BIG ISLAND MINING PROJECT

ENGINEERING CLOSURE REPORT  
BIG ISLAND MINING (XAT-7)  
AND  
ATCHAFALAYA SEDIMENT DELIVERY (PAT-2)

AS-BUILT CONSTRUCTION PHASE

ENGINEERING CLOSURE REPORT  
BIG ISLAND MINING (XAT-7)  
AND  
ATCHAFALAYA SEDIMENT DELIVERY PROJECTS

FIELD CHANGE NO. 4 - DRAWING NO. 5

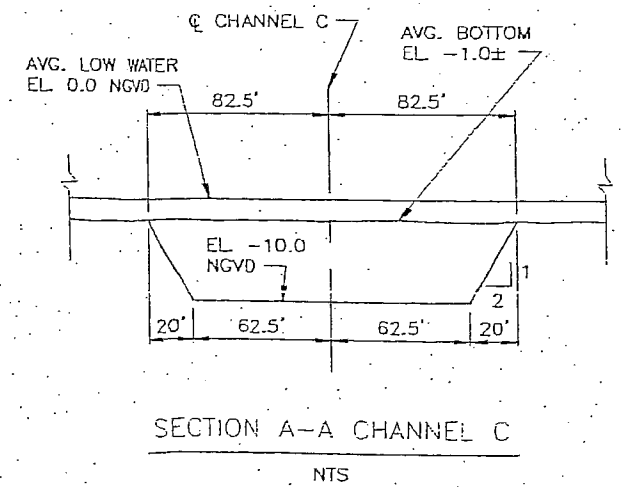
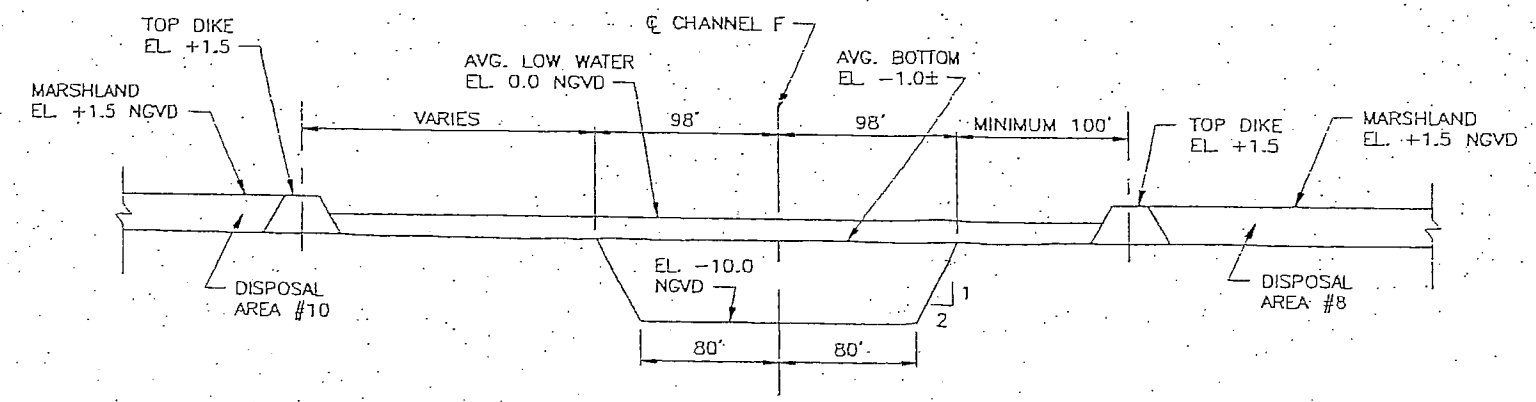
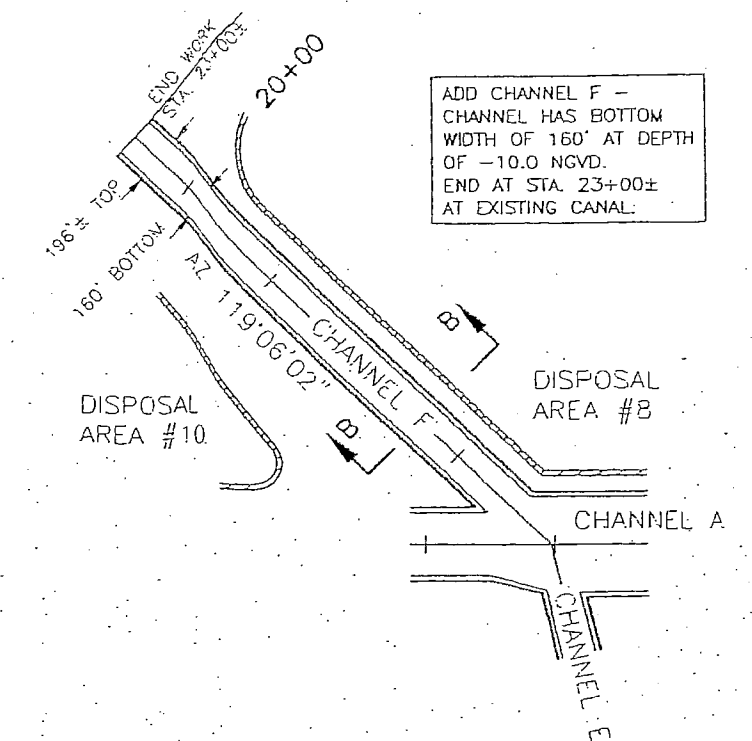
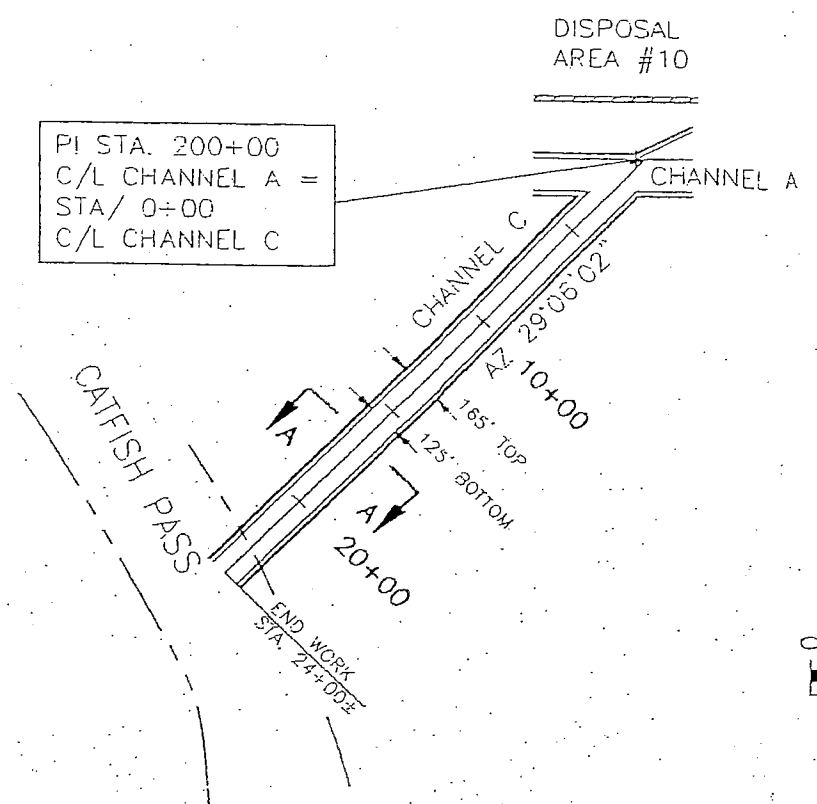
SECTION B-B CHANNEL F  
NTS

SECTION A-A CHANNEL C  
NTS

In addition, add new Channel F starting at station 180+00 of Channel A and extending on an azimuth of 119° 06' 02" to station 22+00± to intersect with the existing pipeline canal. Channel F shall have a bottom width of 160 feet to -10.0 NGVD. Also, extend the Disposal Area No. 8 dike along new Channel F with the bucket dredge to station 20+00 of Channel F. Contractor shall conduct a magnetometer survey prior to doing work along Channel F to insure that no pipelines exist.
